OVERSIGHT GROUP SUBCOMMITTEE WORKSHOP

APRIL 2, 2015

Capitol Square

Level III Design & Construction

Scheme B

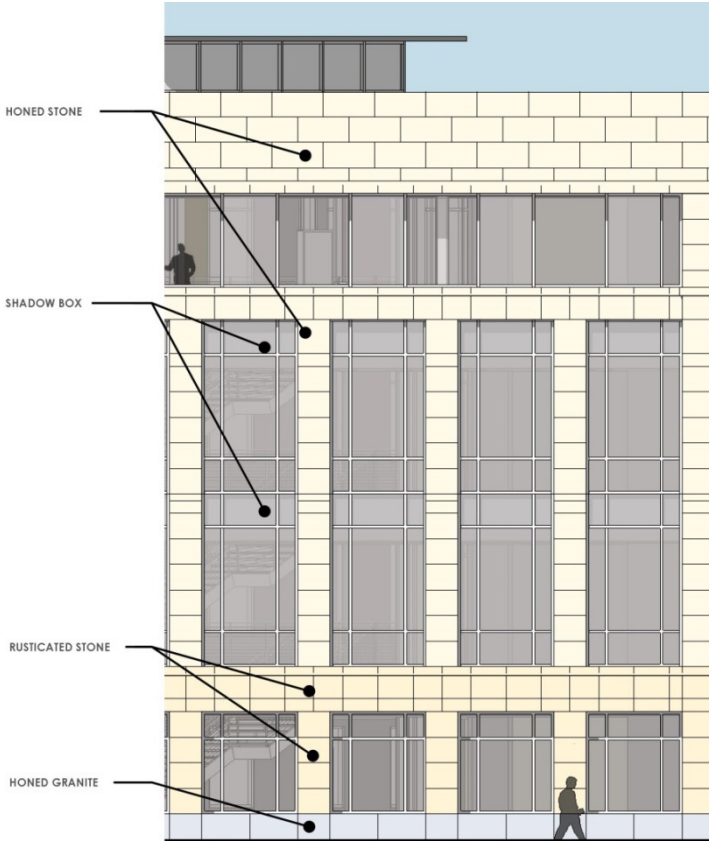
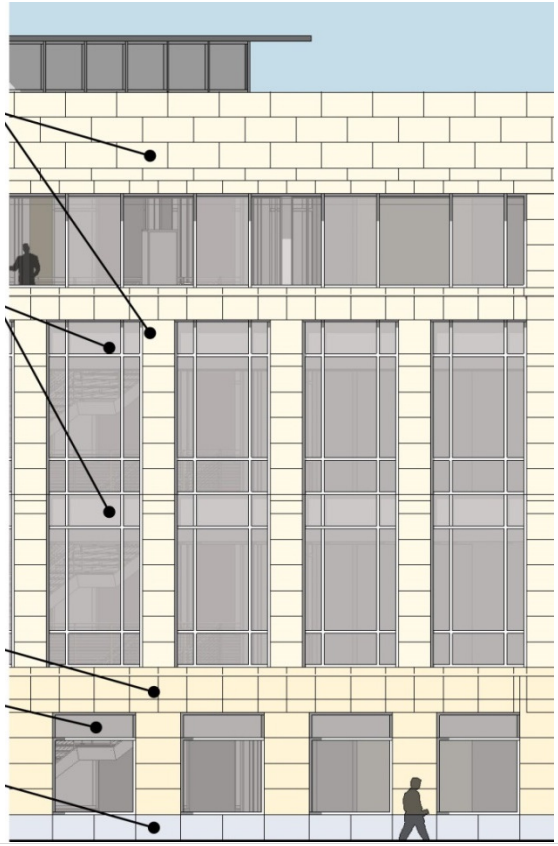
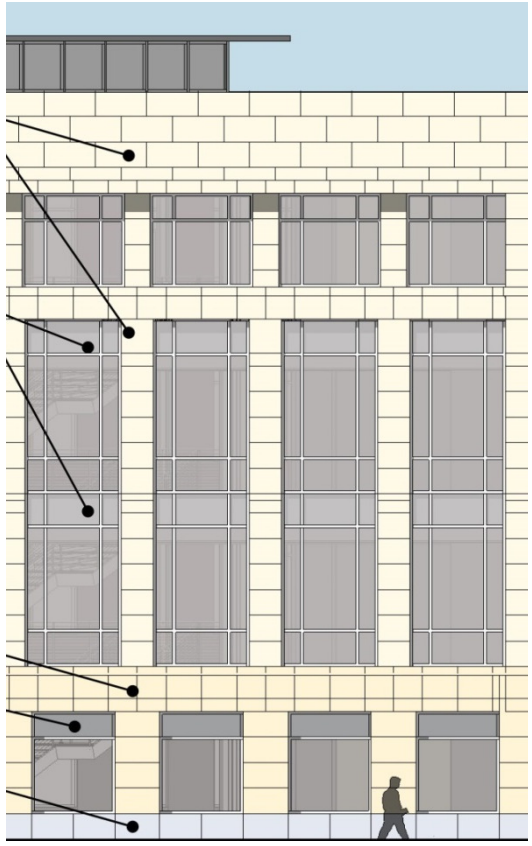
Subcommittee exterior comments

- Step in parapet in K options are not desired move forward with B
- Stair size looks large evaluate ways to reduce its size
- Singular plane pilaster is preferred
- Look at larger window openings at the base
- Continue to look at both glass band and punched windows at 4th floor
- Rustication height appears high at the south entry
- Explore metal brow at entry at the height of the water table
- Cross pattern on addition windows should be avoided
- More contrast in materials
